**SUBMISSION OF MARK T MITCHELL
Consulting Geotechnical Engineer**

Re: Proposed Waikato District Plan – Natural Hazards and Climate Change

4. SLOPE STABILITY REMEDIATION – 37 & 39 BAYVIEW ROAD, COX BAY AREA

<p>Mark T Mitchell Ltd Consulting Geotechnical Engineers 1150 Victoria Street, P.O. Box 9123, Hamilton</p>	<p>WALDEN LEE-SMITH HOUSE</p>	<p>AS BUILT - SITE PLAN SHOWING ANCHOR LOCATIONS</p>	<p>DRAWING No. 12385-20</p>
	<p>Slip Repair No. 39 Bay View Road, Raglan</p>		<p>DATE March 2012 ISSUE One</p>

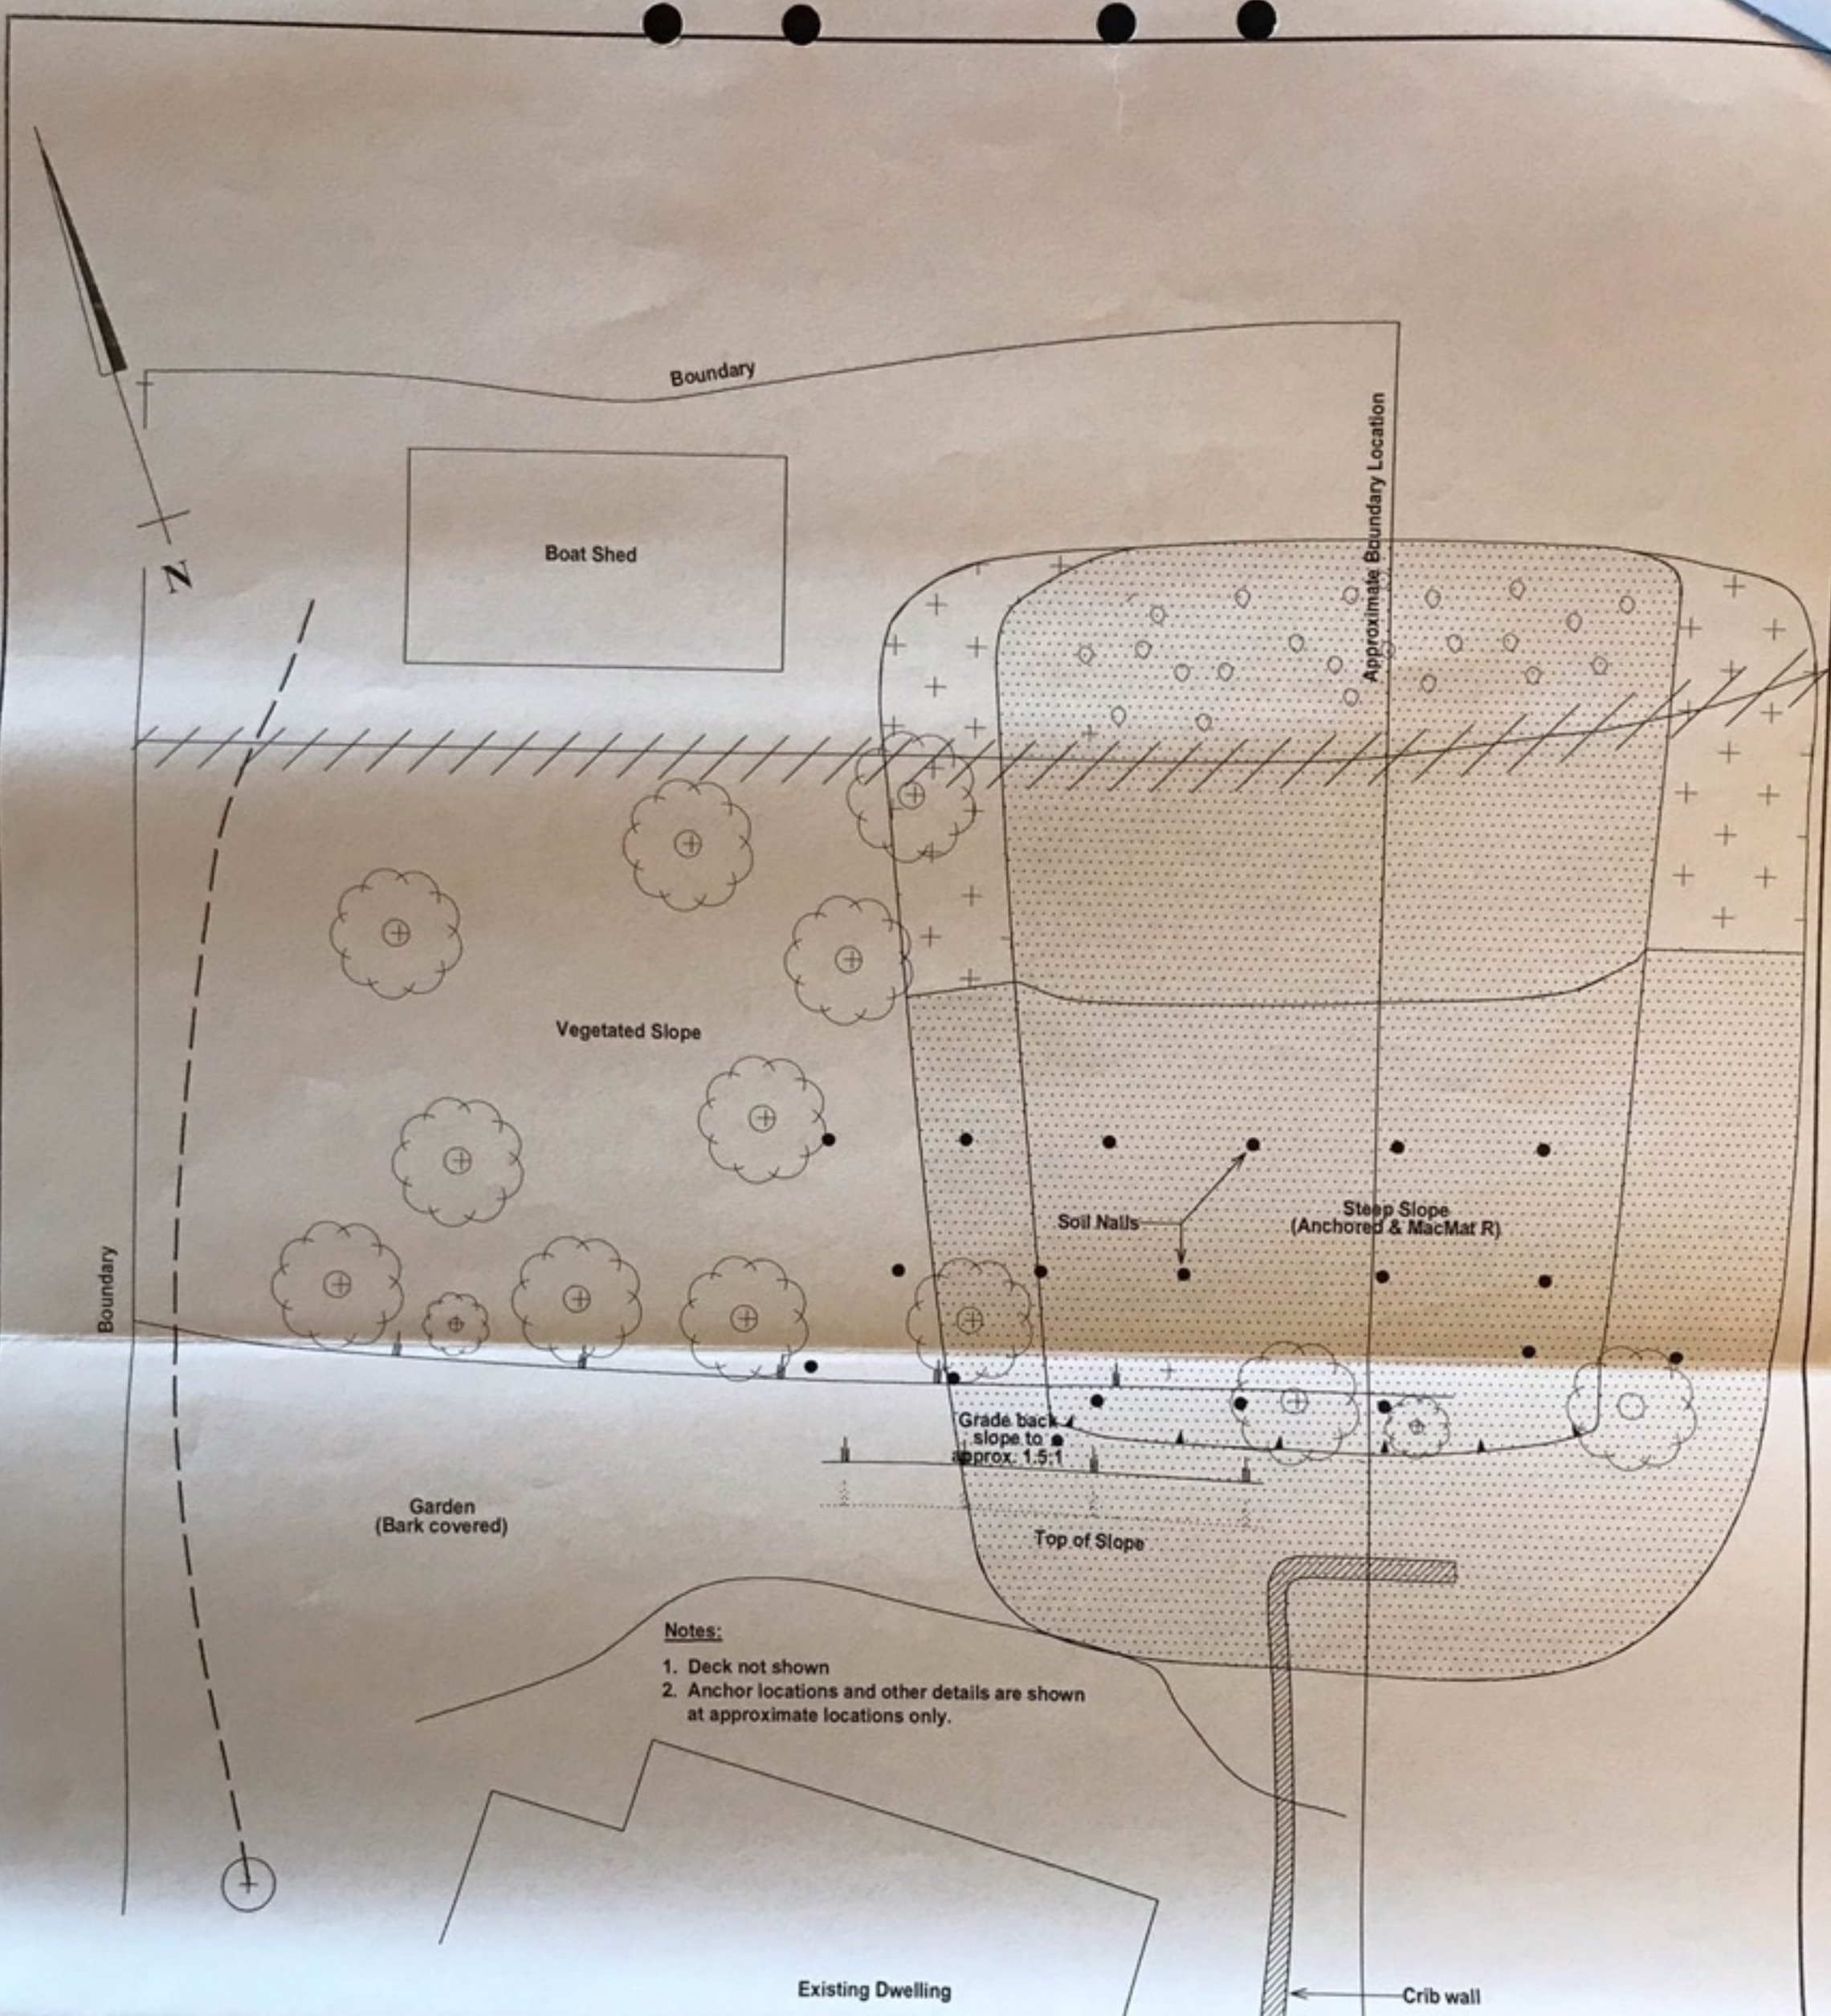
Remedial work carried out on this site which followed the landslip consisted of a series of inclined, drilled-in steel rods encased in concreted holes (termed “soil nails”) at specified 2.5m centres. The exposed slope was then covered with an open fabric matting that is commonly used for slope protection (MacMat R) and then topsoil covered and seeded.

Due to the slope stabilization works that were carried out in 2010 and the documentation I have supplied to Waikato District Council Building Department.in my opinion the new Proposed District Plan restrictions are not realistic. Furthermore the property at 39 Bayview Road should not carry the aforementioned strict building limitations.

Instead of the proposed contour overlay line that WDC has shown as the High Risk Coastal Area it should be dramatically reduced on this concerning property, with that line brought forward to at least where a WDC Consent has already been granted for the current building structures.
